WCAP-16500-NP-A
Revision 0

CE 16x16 Next Generation Fuel Core Reference Report

SUBJECT: FINAL SAFETY EVALUATION FOR WESTINGHOUSE ELECTRIC COMPANY (WESTINGHOUSE) TOPICAL REPORT (TR) WCAP-16500-P, REVISION 0, "CE [COMBUSTION ENGINEERING] 16X16 NEXT GENERATION FUEL [(NGF)] CORE REFERENCE REPORT" (TAC NO. MD0560)

Figure 2-13

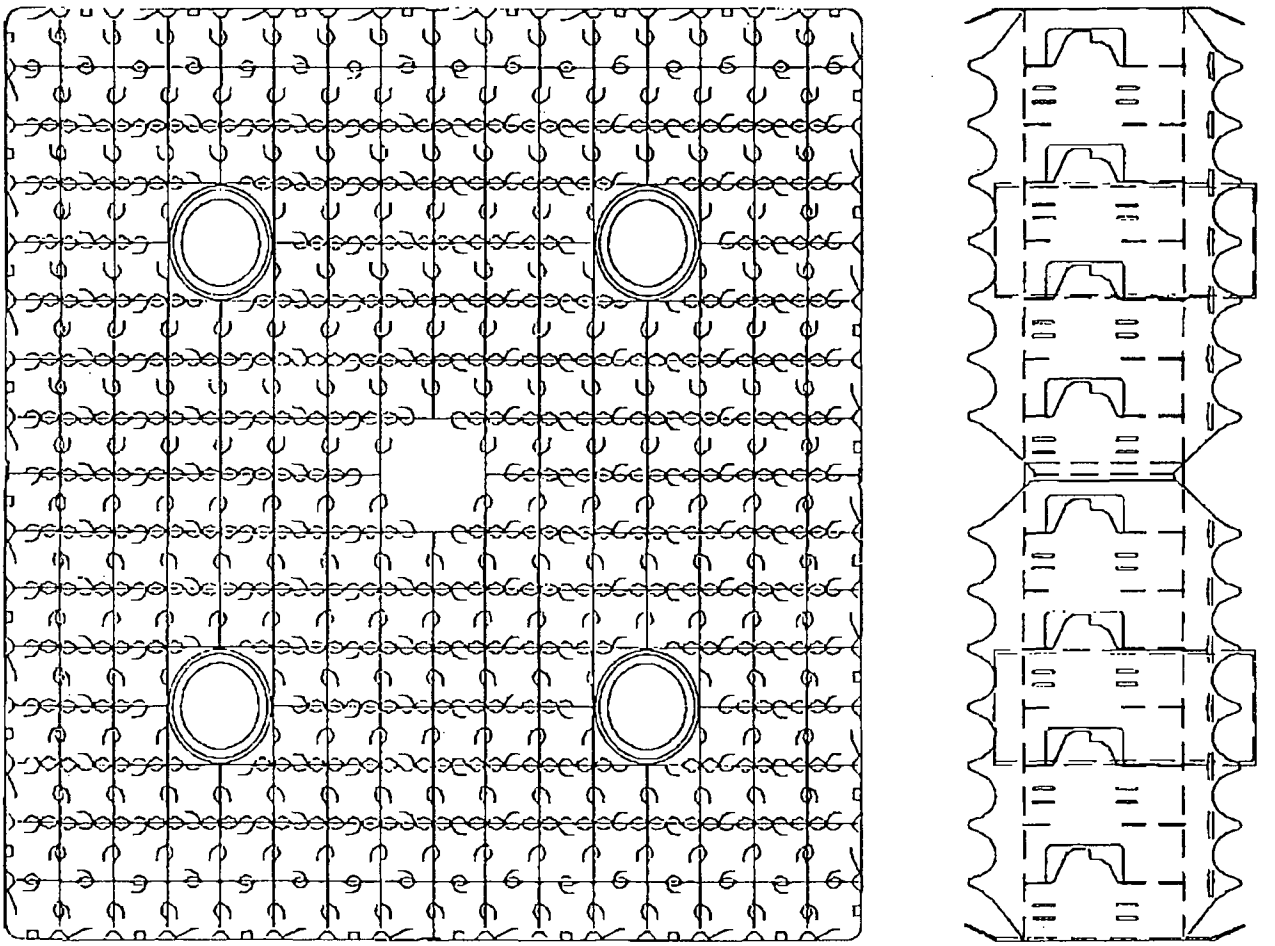
- The top, Mid, and IFM grids are attached to the guide thimbles by bulging the thimbles into sleeves that are connected to the grids (Figure 2-6). On the standard design the Zircaloy-4 grids are attached to the thimbles by welding, while the Inconel top grid, if applicable, is retained by rings that are welded to the guide tubes above and below the grid. The bulged design was selected for NGF to improve fabrication while preserving the rigidity of the fuel assembly structure.
- The NGF guide tube flange is connected to the guide thimble by bulging the guide thimble into the flange (Figure 2-6), in lieu of by welding as in the standard design. The bulged design was selected for NGF to improve fabrication while retaining adequate strength.
- Changes were made to the Guardian™ grid (Figure 2-13) [
